SUNDRY NOTICES AND REPORTS ON WELLS
Do not use this form for proposals to drill or to re-enter an
abandoned well. Use form 3160-3 (APD) for such proposals.

Jenkins B Federal # 15 WIW

Permanent Abandonment of Federal Wells
Conditions of Approval

Jenkins B Federal # 15 Wellbore diagram.xls

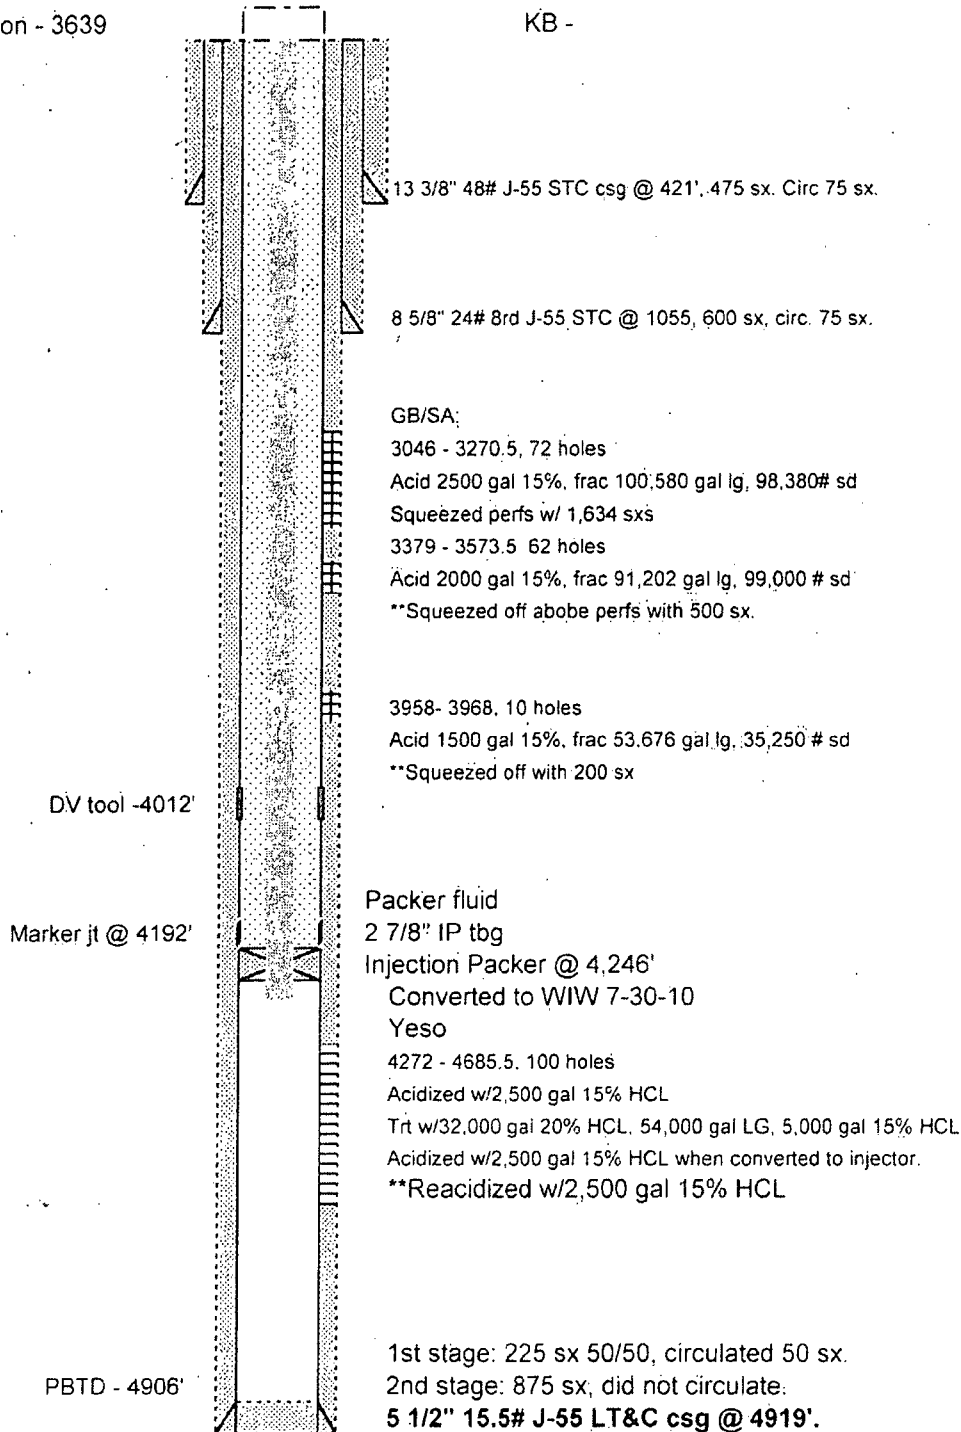
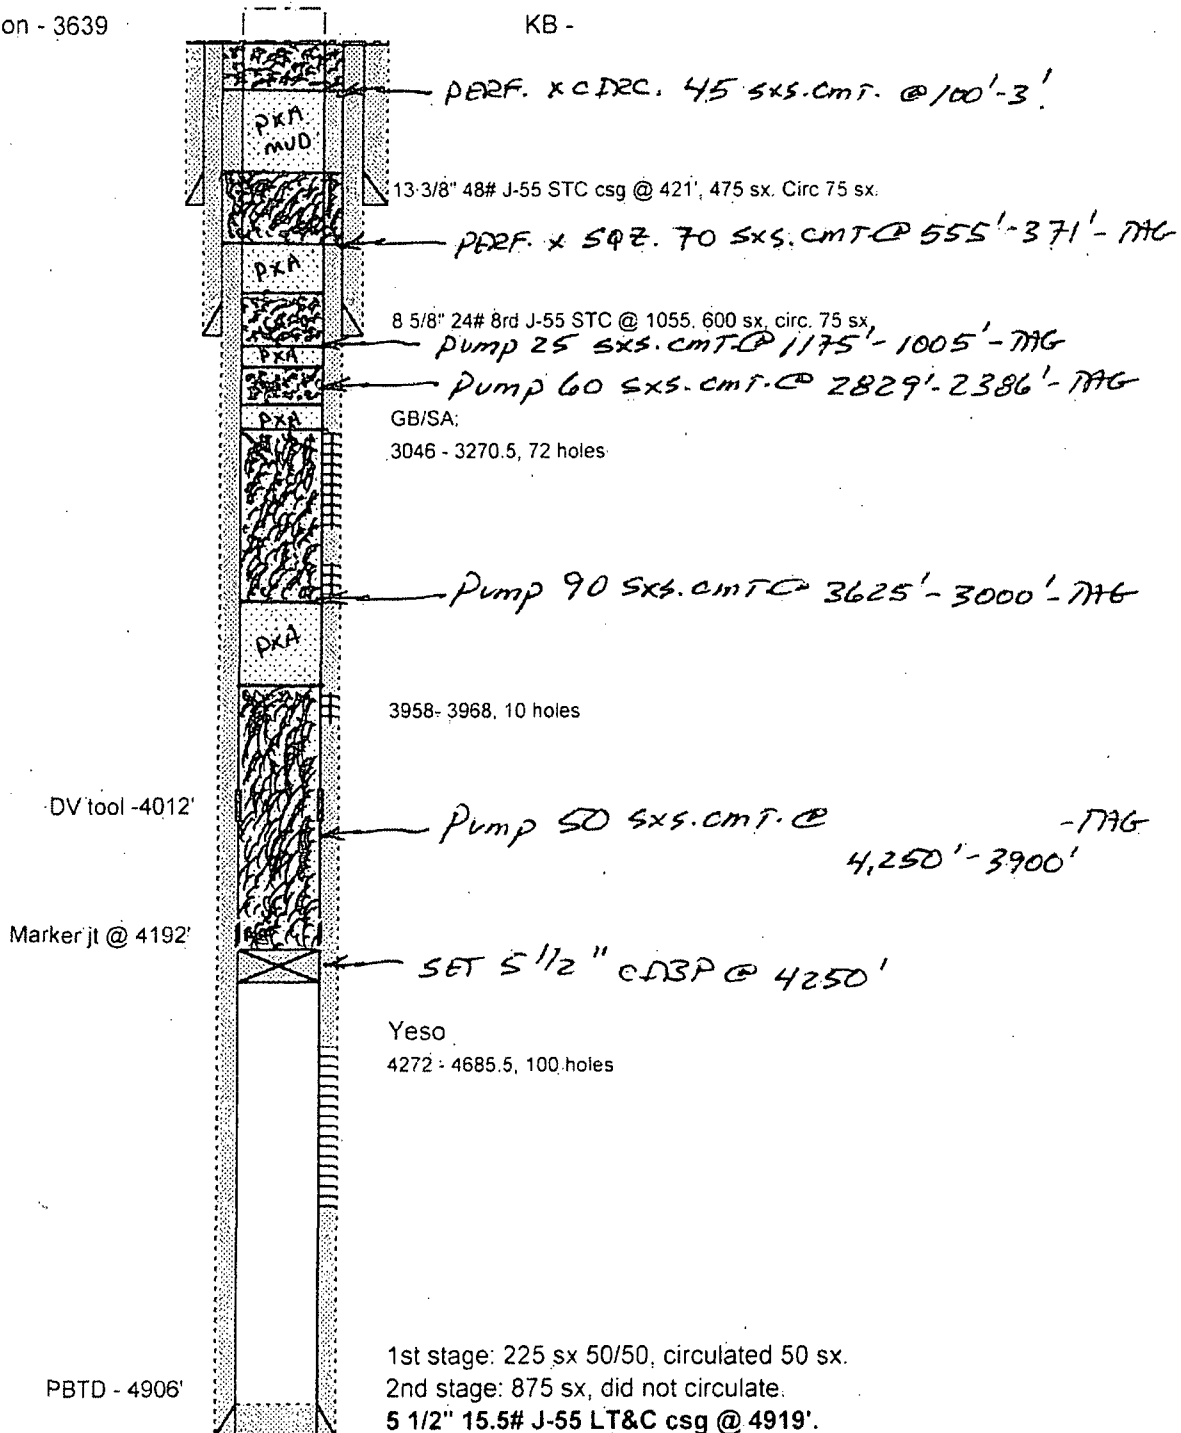
Below ground level dry hole marker required (LPC)

**** BLM REVISED ** BLM REVISED ** BLM REVISED ** BLM REVISED ** BLM REVISED ****
